Written Submission
for the
Royal Society for the Protection of Birds
ANNEX 1
Flamborough and Filey Coast SPA

**Application by Norfolk Vanguard Limited for an Order
Granting Development Consent for the Norfolk Vanguard Offshore Wind
Farm**

Response to October 2021 consultation on further information

Planning Inspectorate Ref: EN010079

Figure 1: map showing location of East Anglia zone wind farm schemes in relation to Lowestoft¹⁰

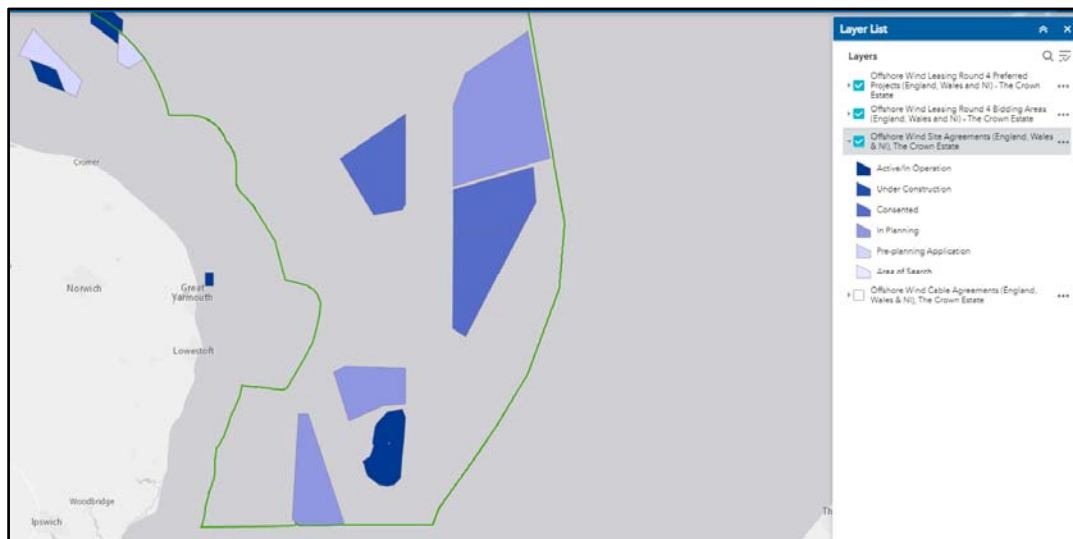
- 4.13 We have a number of comments on this section and set them out in sequential order:
- **Paragraph 116 – food supply:** the Applicant appears to be relying on Dogger Bank as a key food supply for kittiwakes which might colonise its artificial nesting structure (which we note later has a preferred location of Lowestoft). We make three simple points and suggest it would be inappropriate for the Secretary of State to rely on the Dogger Bank as a food supply in this context:

- Dogger Bank lies a significant flying distance from the Applicant's preferred location of Lowestoft, so it is unlikely to be a preferred feeding area;

- Dogger Bank is already known to be one of several feeding areas for kittiwakes from the FFC SPA, so if the Applicant is correct this would increase competition for the same food resource;

- Phases 1-3 of the Hornsea offshore wind farm zone lie in a direct path between Lowestoft and the Dogger Bank, which would result in collision risk.
- **Paragraphs 117 & 146:** at paragraph 117 the Applicant acknowledges that any birds which either colonise or are recruited from the proposed artificial nest structure will themselves be at risk of collision with offshore wind farms. However, at paragraph 146, the Applicant counters this argument by claiming that birds breeding in Norfolk and Suffolk are likely to forage closer to their nests (c.f. reliance on Dogger Bank above) and are at lower risk of encountering wind farms. This is plainly incorrect as any review of a map of current, consented and planned offshore wind farms adjacent to the East Anglia coast would show. Given the Norfolk Vanguard scheme is one of 5 such schemes in the East Anglia zone itself, we are surprised such a claim would be made. In fact, we consider this to be an area of high risk of collision with turbines for kittiwakes from this stretch of coast over the medium to long-term particularly if further East Anglia zone schemes are consented. A simple review of The Crown Estate's map of offshore wind farm zones (Figure 1 below) confirms that the East Anglia zones are all within the known maximum foraging range for kittiwakes and several within or close to the mean foraging range. This is further reason why the precise details on the location of the compensation measure are essential: to enable collision risk to be discussed, and as far as practicable, assessed in the context of the proposed new colony.
